BEACON LITE ROAD STOCKPILE

CONSTRUCTION DRAWINGS AMENDMENT

EDARP FILE NO.: CDR261

GRADING & EROSION CONTROL PLAN - FINAL - AMENDMENT

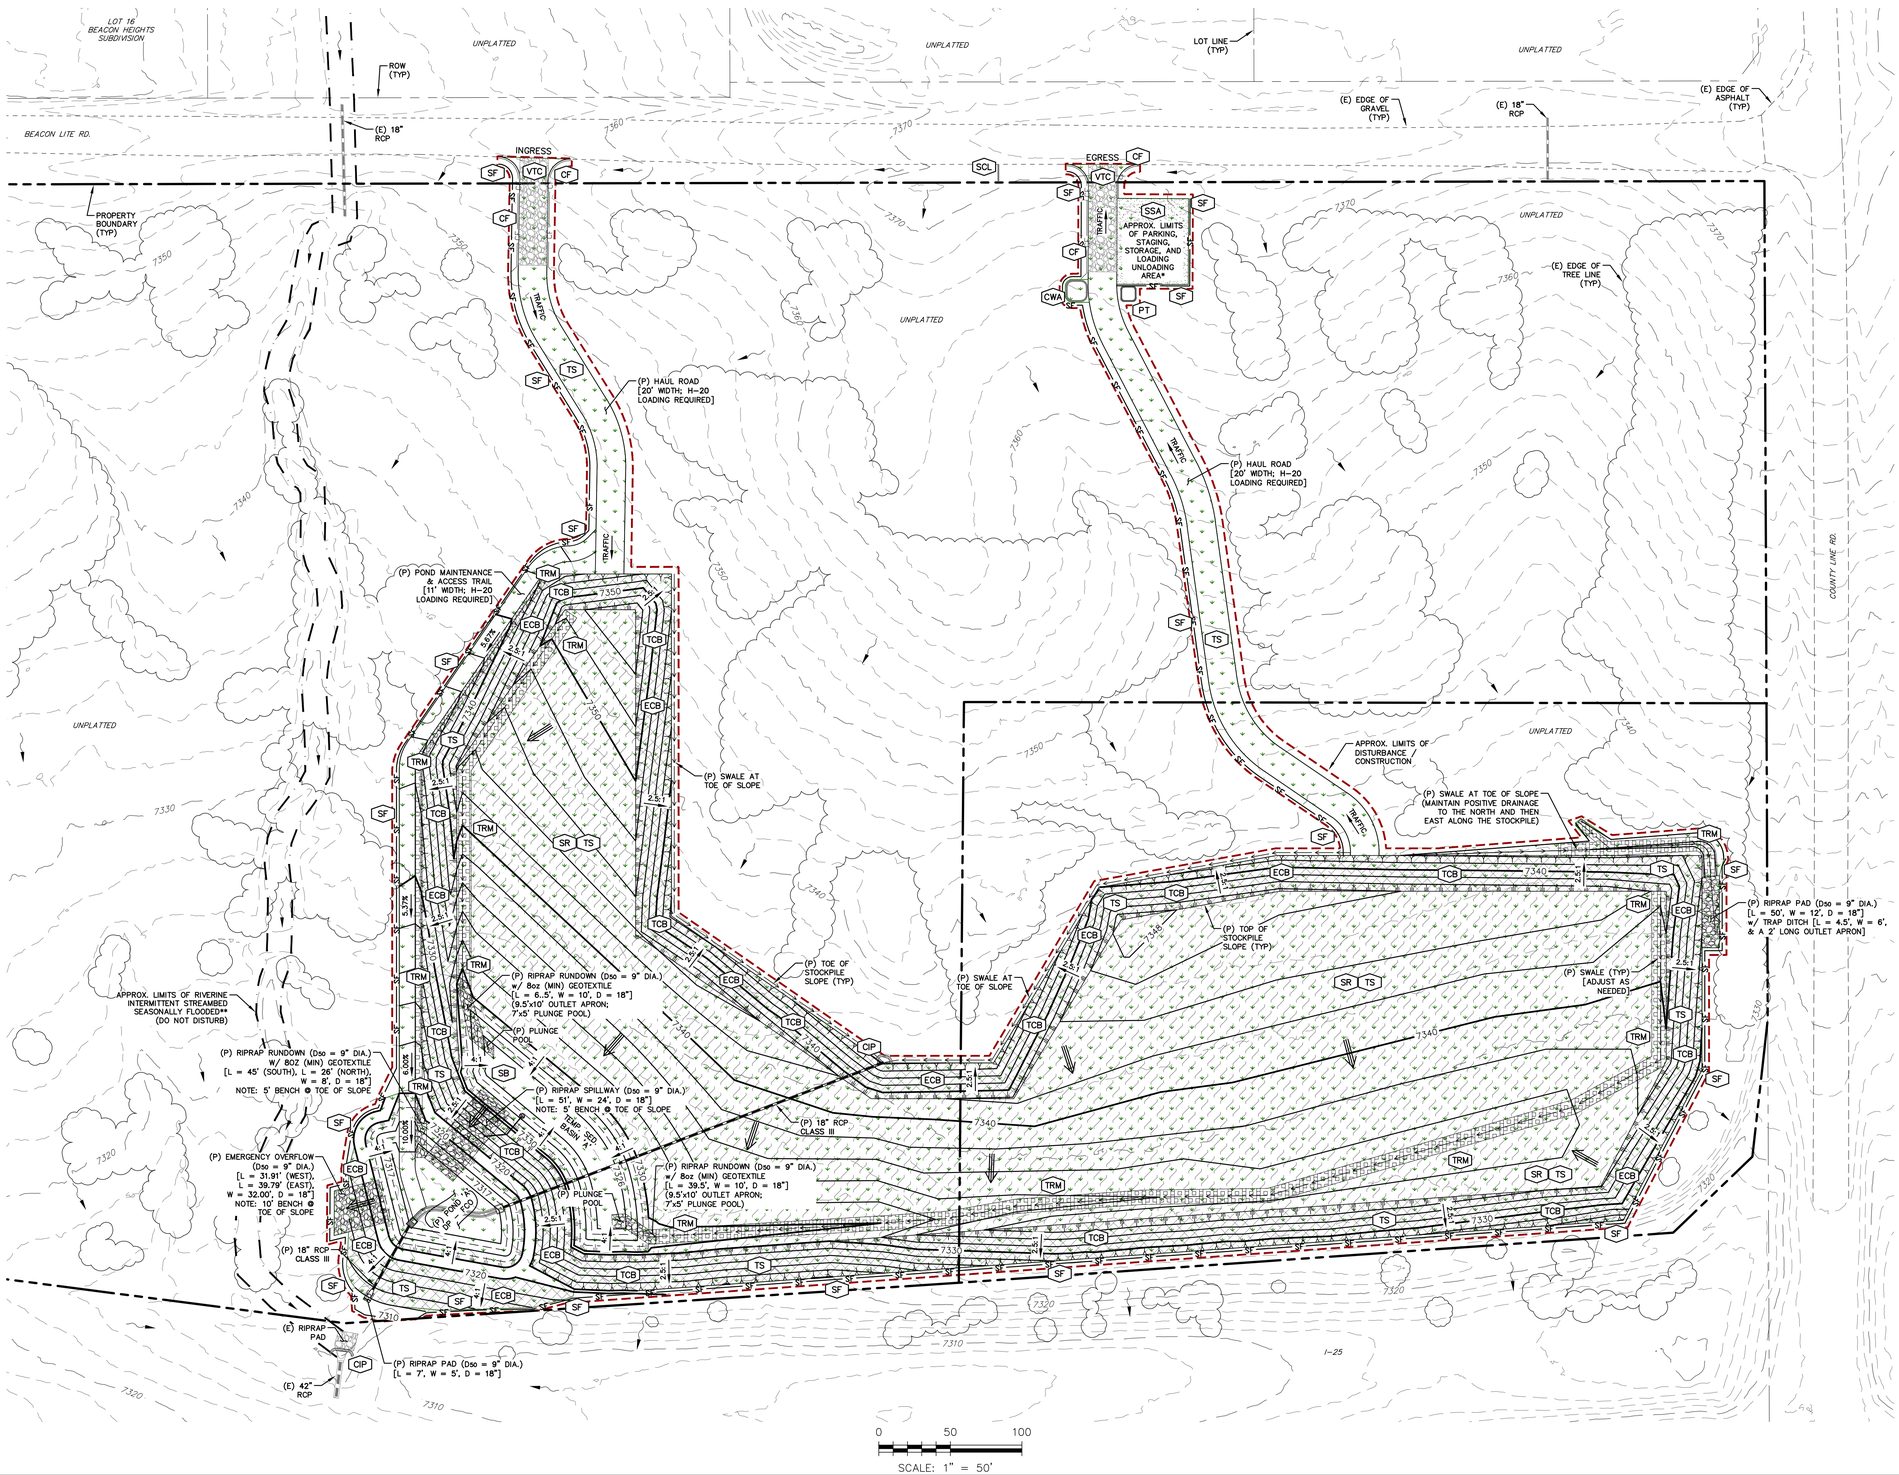
This proposed pond linework does not match what is shown on page 10 below. Page 10 no longer shows both original and proposed. It just shows original. So are you planning to modify this pond or not?

Sheet 10 is the Original Pond Design; Sheet 11 (which is missing from this set) shows the Amended Pond Design.

GRADING & EROSION CONTROL PLAN STAGING AREA - AMENDMENT

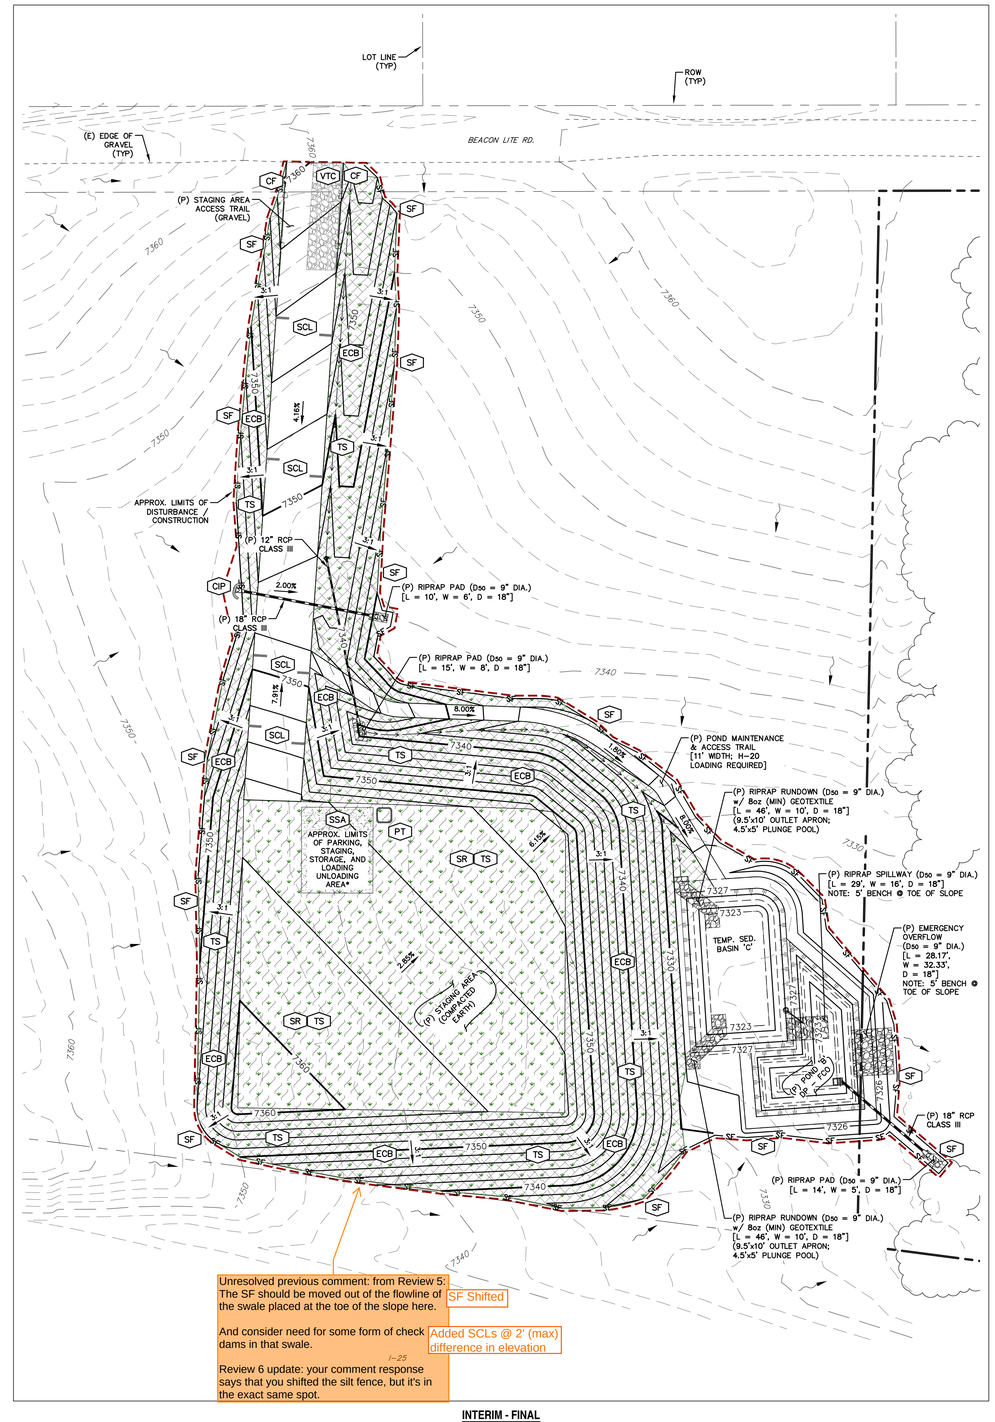
Unresolved previous comment: from Review 5: The SF should be moved out of the flowline of the swale placed at the toe of the slope here.

And consider need for some form of check dams in that swale.

Review 6 update: your comment response says that you shifted the silt fence, but it's in the exact same spot.

Added SCLs @ 2' (max) difference in elevation

PERMANENT CONTROL MEASURE PLAN

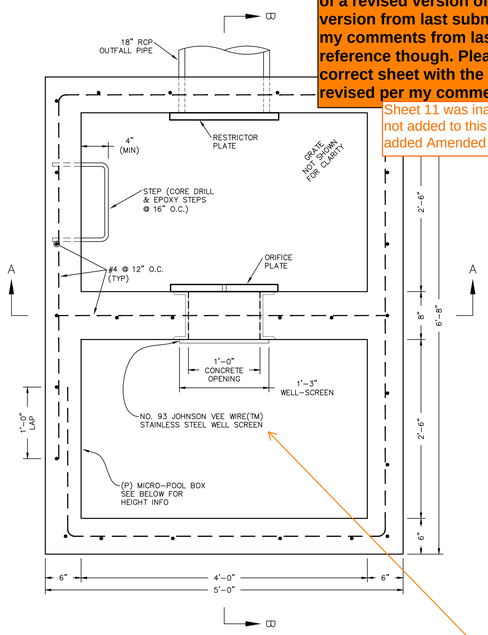
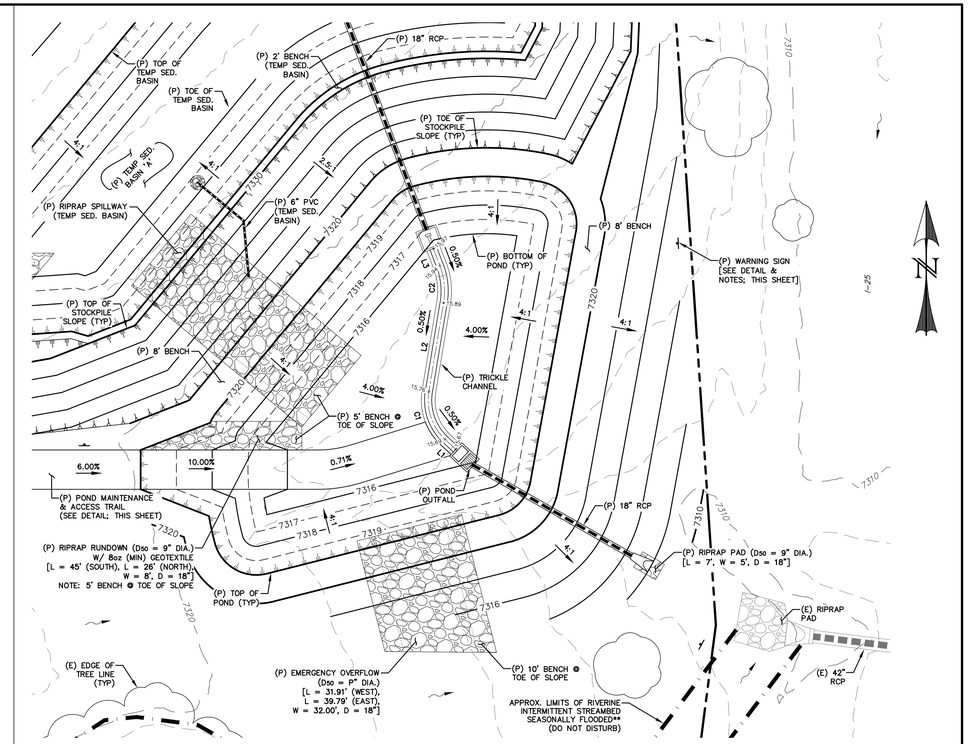
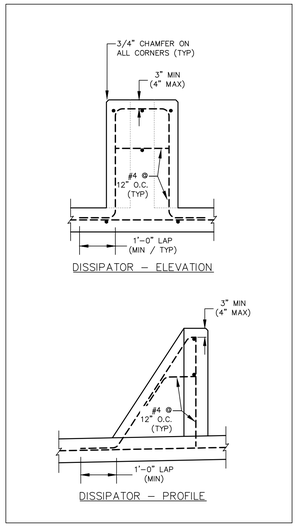
It looks like you accidentally included the previously approved (2025) version instead of a revised version of the "Amended" version from last submittal. I copied over my comments from last review for reference though. Please include the correct sheet with the next submittal, revised per my comments below.

Unresolved comment from Review 5:

Please provide more detailed gasket info like thickness, width, brand/model, etc.

Unresolved comment from Review 5: Flattened expanded metal is not an equivalent alternative to what is in our criteria.

Unresolved comment from Review 5: Revise text for size discrepancy. Calcs and detail in upper left of this sheet show 2.5'x4'

Sheet 11 was inadvertently not added to this set; added Amended Sheet.

The gasket shall be made of 1/4-inch thick, 60 durometer EPDM rubber in a continuous sheet the size of the orifice plate. The sheet shall be placed between the orifice plate and the concrete wall, with the width of the overlap between the plate and the concrete. Openings shall be cut into the sheet corresponding to the plate bolt holes and the concrete wall opening, cuts made either by the contractor in the field or by the manufacturer. Or equivalent gasket approved by EPC. Note that caulk is not an approved equivalent and will not be accepted by EPC.

Added Notes RE Gasket

??? The opening IS 2.5'x4'...the Trash Rack is Larger so it can be mounted to the top of the structure.

SECTION A-A
SCALE: N.T.S.

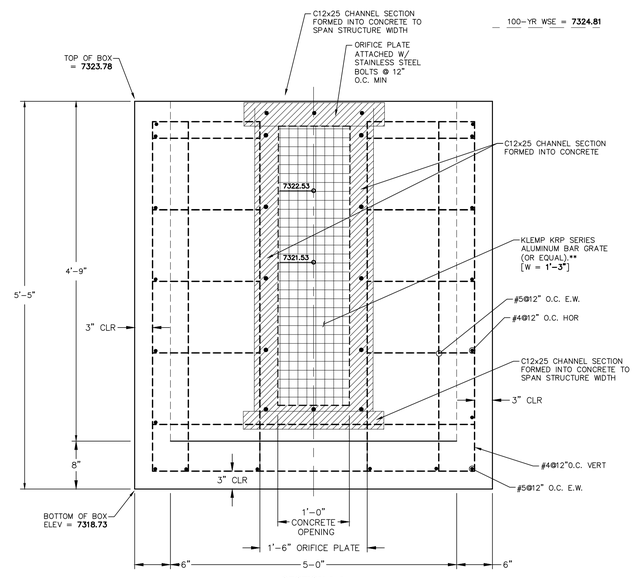
delete "5/16" because the note in the title block below calls for 1/4" thick

Corrected
it's not a well screen, it's a bar grate. Revise so contractor does not order a well screen.

The Orifice Plate is 5/16" thick; the Gasket is 1/4" thick

SECTION B-B
SCALE: N.T.S.

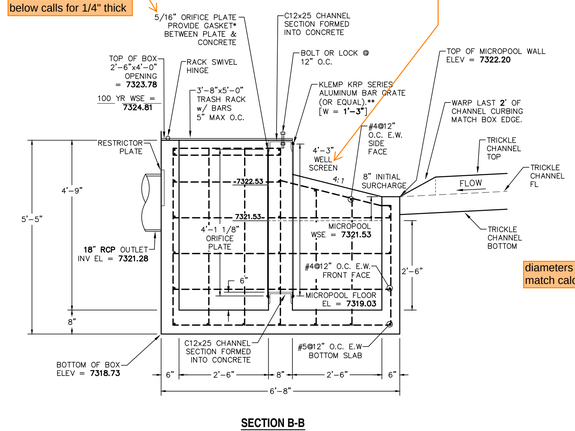
diameters do not match calls
